REPORT OF: URBAN DESIGN COMMISSION	PRESENTED: August 17, 2011	
TITLE: 5115 University Avenue – PUD(GDP-SIP) for a Mixed-Use Development in UDD No. 6. 19 th Ald. Dist. (23464)	REFERRED:	
	REREFERRED:	
	REPORTED BACK:	
AUTHOR: Alan J. Martin, Secretary	ADOPTED:	POF:
DATED: August 17, 2011	ID NUMBER:

SUBJECT: **5063-5119 University Avenue & 702 N. Whitney Way – Rezoning– C3 to PUD (GDP) / Demolition of 11 commercial buildings; GDP for construction of mixed-use development; SIP for medical clinic; Preliminary and Final Plat of University Crossing**

**ADDENDUM TO TRAFFIC STUDY - UNIVERSITY CROSSING
UNIVERSITY AVE – WHITNEY WAY INTERSECTION
City of Madison, WI
Prepared by Mary Greuel, KL Engineering
September 13, 2011**

4.3 CONCEPT MASTER PLAN

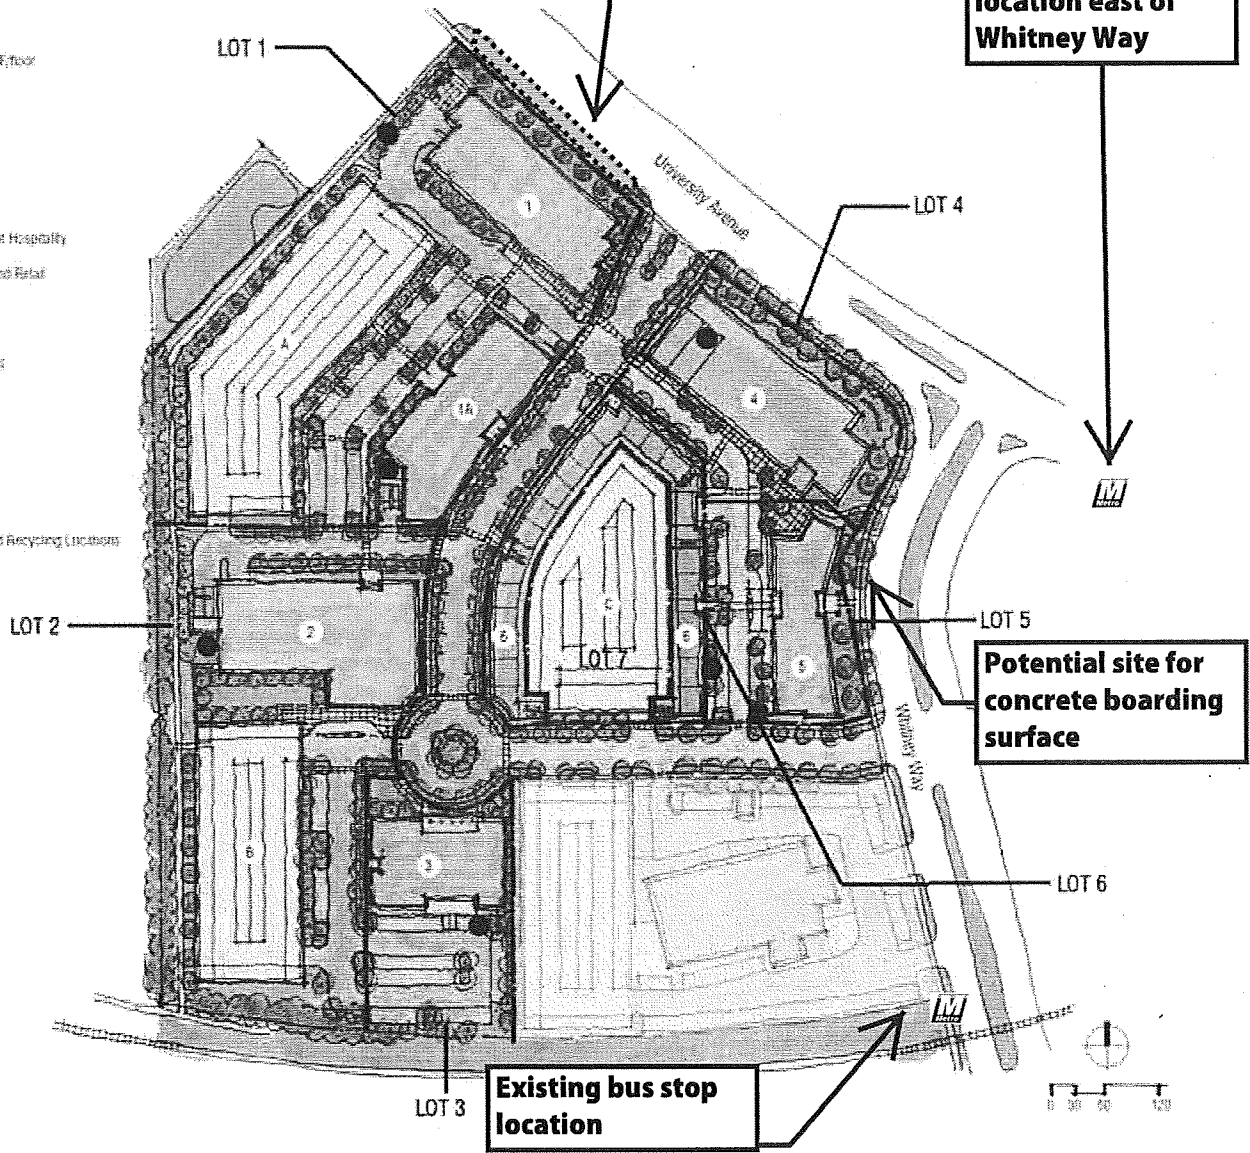
Planned bus stop location opposite Flambeau Road intersection.

Area of potential bus stop pullout lane, and passenger amenities, for new bus stop location.

Planned bus stop location east of Whitney Way

UNIVERSITY CROSSING - HALF SIGNAL GEOMETRY

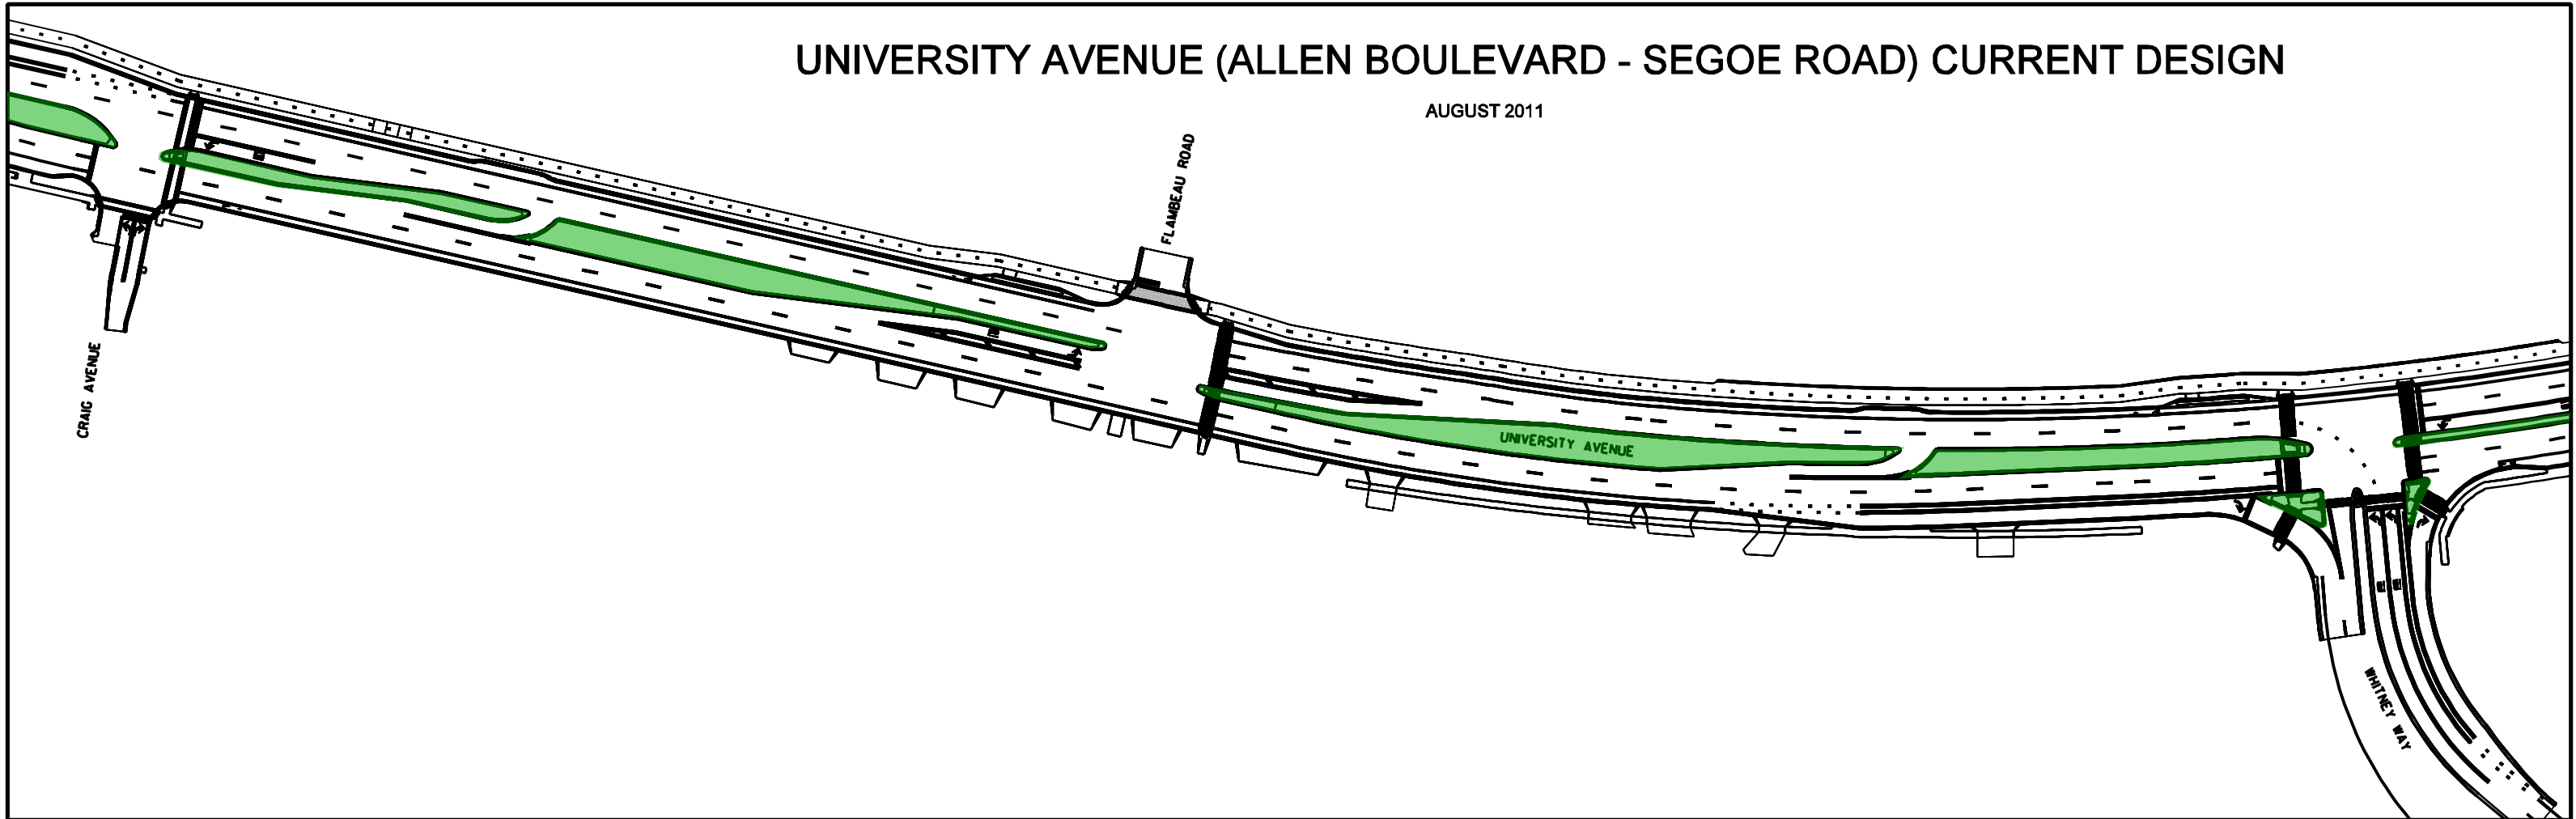
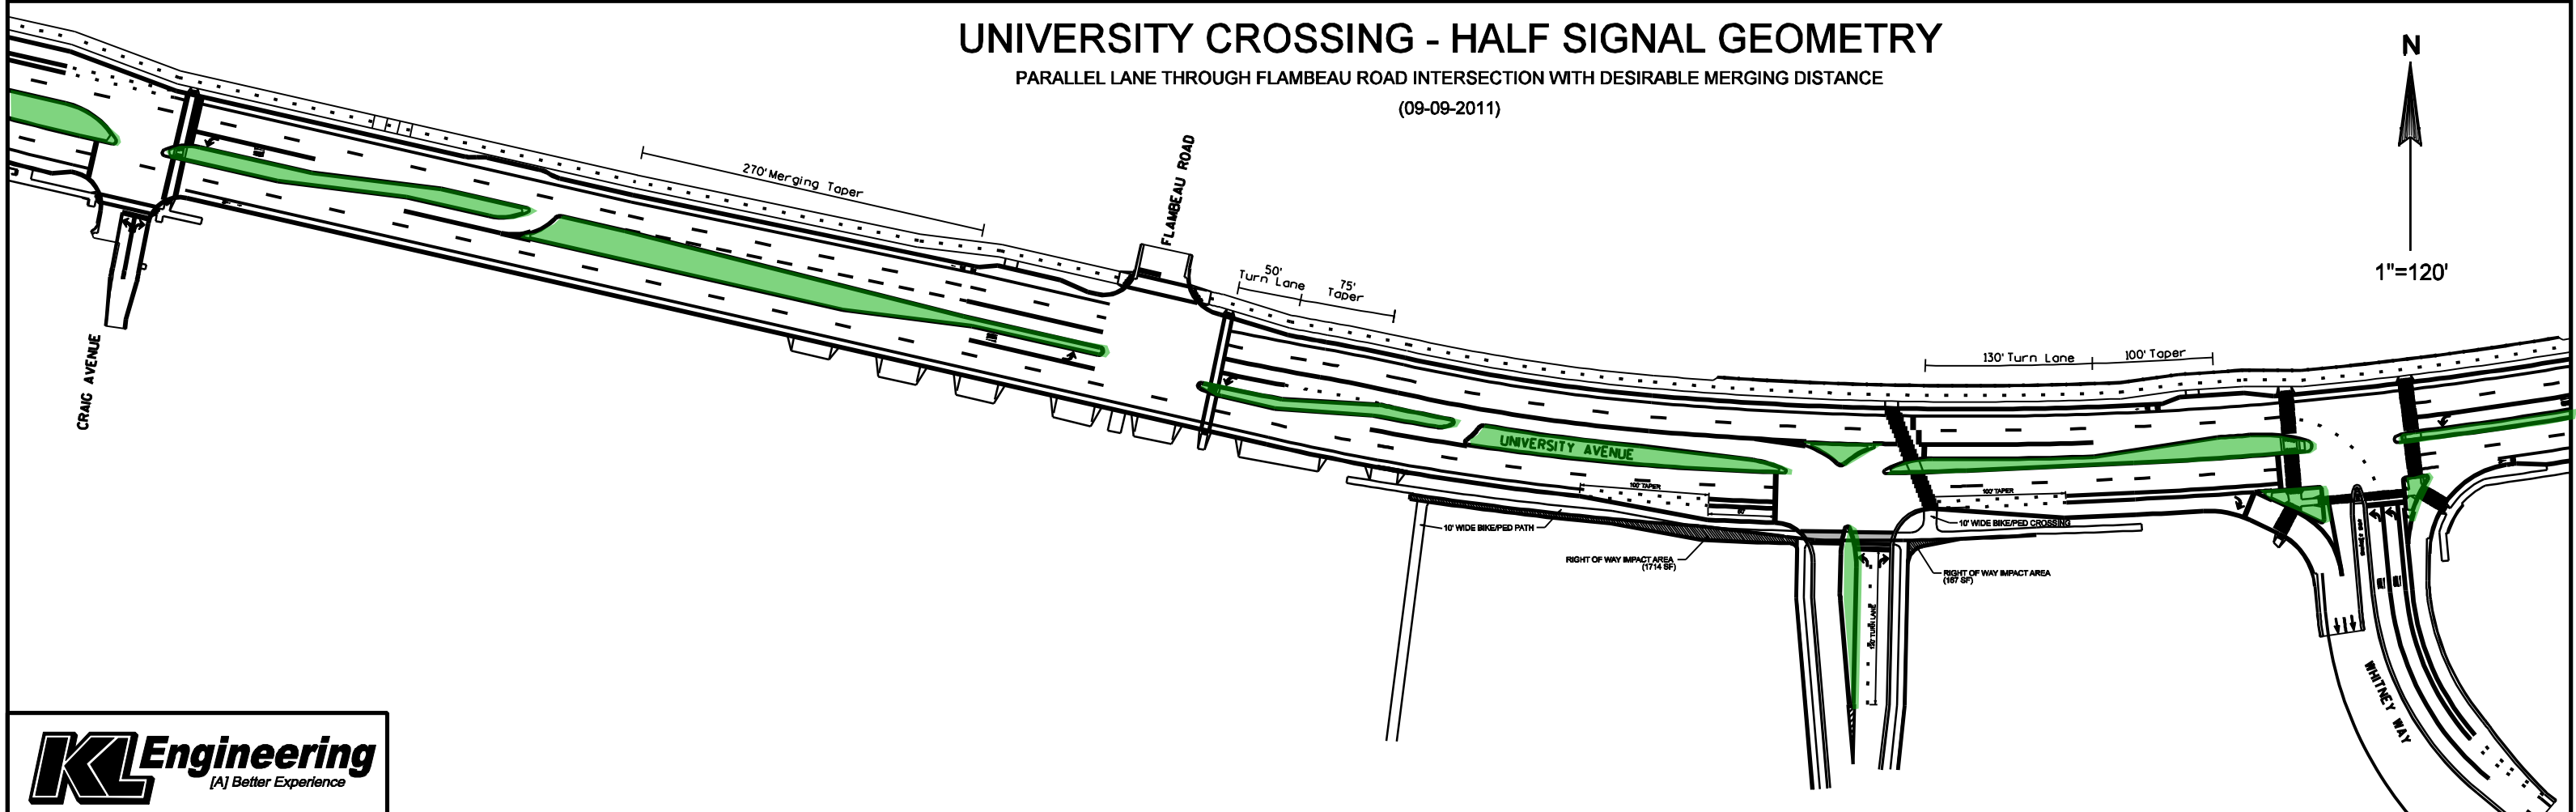
At the request of the City of Madison Traffic Engineering Department a modified version of a “half” traffic signal at the proposed intersection of University Avenue and University Crossing was evaluated. The City prefers a “half” traffic signal to a full signal because they prefer to avoid stopping outbound University Avenue.

The concern with the half signal as discussed in the traffic study includes the short distance allowed for the merge with minimal gaps in traffic, specifically during PM peak hours. Although this might be feasible in the short term, as traffic volumes on University Avenue and Whitney Way increase, the merge would become increasingly difficult and could result in a back up of traffic in the merging area. Additionally, because the merging area is so close to the University Avenue – Whitney Way intersection, vehicles arriving in queues from the east on University Avenue and from Whitney Way will still be tightly packed resulting in merging being difficult during some time periods of the day. To alleviate some of these issues, a long term option was suggested by the City of Madison which includes a “half” traffic signal with a third lane added to westbound University Avenue through the Flambeau intersection.

The new proposed “half” signal option includes the third lane westbound which is added at the development access point and continues as a full eleven foot lane through the Flambeau Road intersection. This third lane would then merge into the other two lanes of westbound University Avenue between Flambeau and the U turn bay east of Craig Avenue. This design results in approximately five additional feet of total street width. The eleven feet required is taken from the median and by relocating the north curb line of University Avenue approximately five feet to the north. This design can be constructed within the existing right-of-way (ROW) with the exception of the additional ROW already required from the developer to build the half signal option discussed in the report.

In comparison to the previous “half” signal proposal, this option results in a longer and therefore safer merge opportunity for traffic exiting the development and eliminates the possibility that traffic attempting to merge will back up through the University Crossing intersection. Because outbound University Avenue and left turning traffic from Whitney Way does not have to stop at the access point, this alternative also results in safer, more efficient movement of traffic for these movements when compared to a full traffic signal. It does require that traffic attempting to left or U turn at the Flambeau Road intersection cross the third lane to enter the westbound turn lane there.
